## Description of Changes

Item	Control (SM9GV -> OTR_PF1_23)
Before	
After

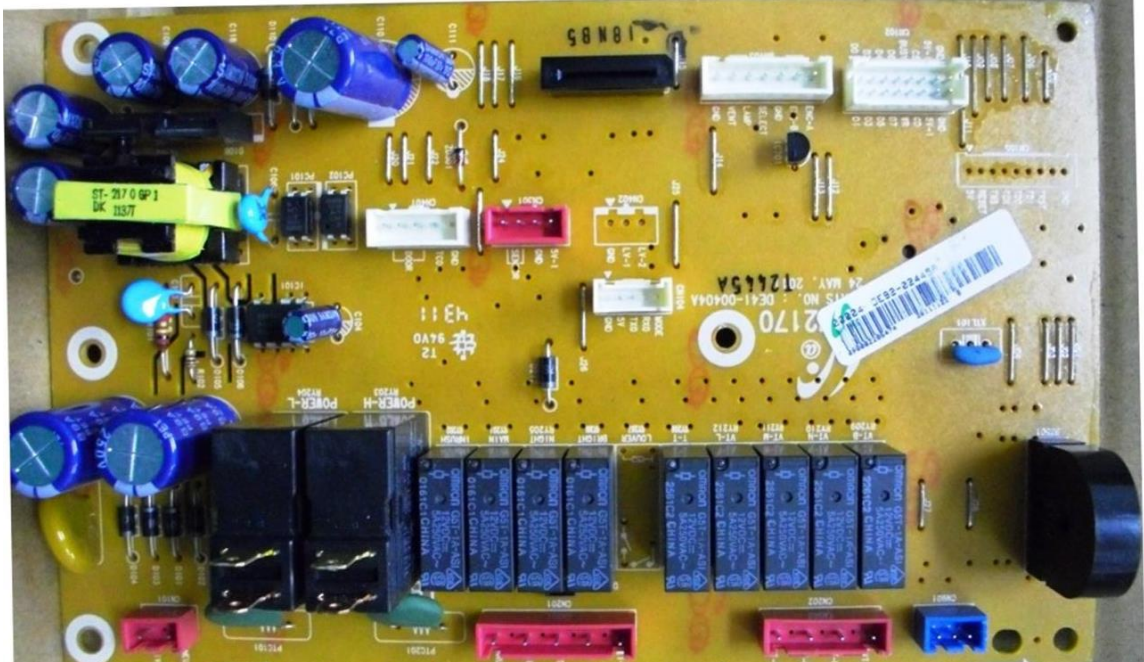
- There is change of control board
  - Add wireless module by FCC certified
  - New control board (Non-transmitter portion)
    - Overcurrent protection design (Fuse+add NCT)
    - Temperature protection design (add OTP circuit)
